perc quickMCEF-200
Rev: 4/07Mineral County Health Department
Application for Individual On-site Sewage Evaluation304-288-1321 Health Dept
Denny Tidgell
Name JEFFREY A METCALF Phone 304-813 9298Address RT 1 Box 1276 BURLINGTON WV 26710Property Location RT 46 TOWARDS FORT AUBRY FOREBACK RD ON LEFT
1-MILE ON LEFT TOP OF HILLProperty Deed Recorded in: Book No. 263 Page 645 Date Recorded 3/15/91County Tax Map _____ Parcel Number _____ Size of Lot 7 + ft² (acres)

Plot Layout

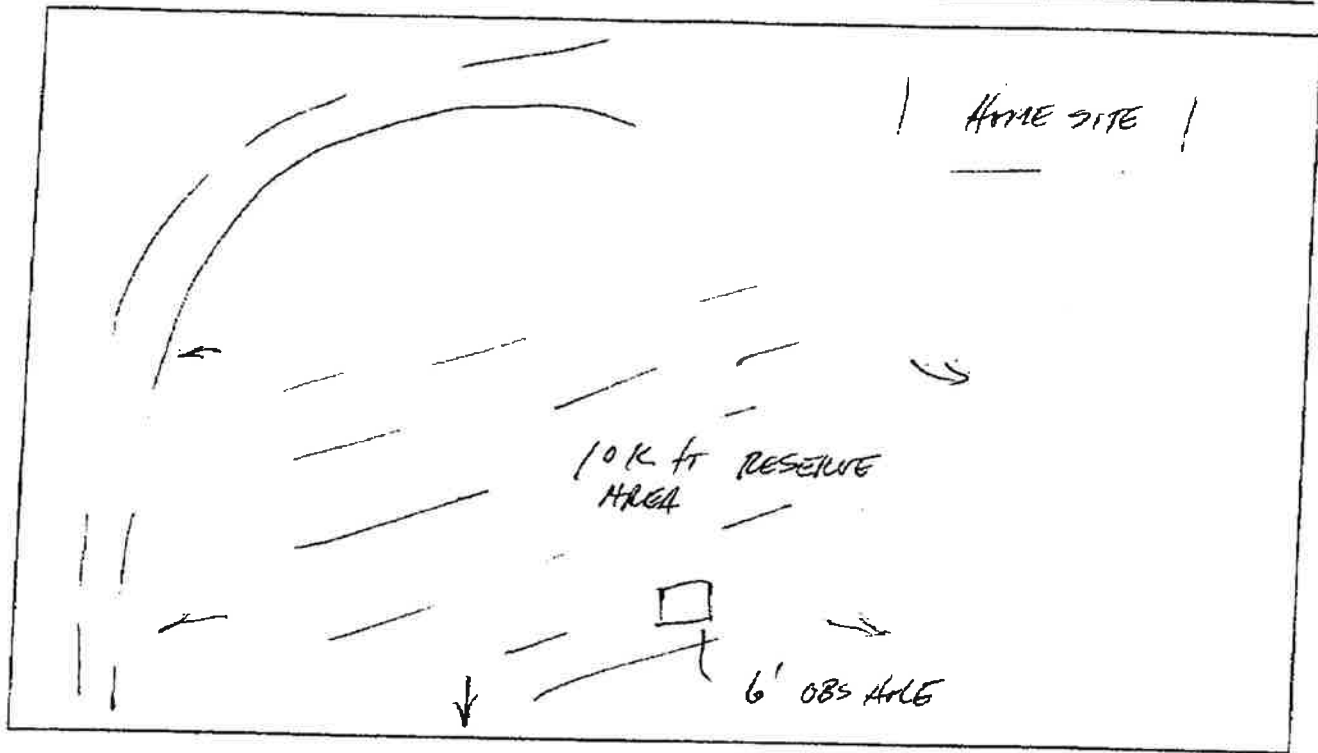
6' Excavation Observed	Reserve Area Location (GPS Coordinates)	Drainfield Design		
		Depth	ft ² of Trench Area	Trench Separation
48" LOOSE SAND/SILT 48" → BOTTOM RIGHT SAND/CLAY/2014 DRY	39 28 .2 78 49 21.4	24" MAX	400 ft ² / BR.	6'

Comments: CL I SYS TO BE OVERSIZED DUE TO TIGHTNESS AT 48"
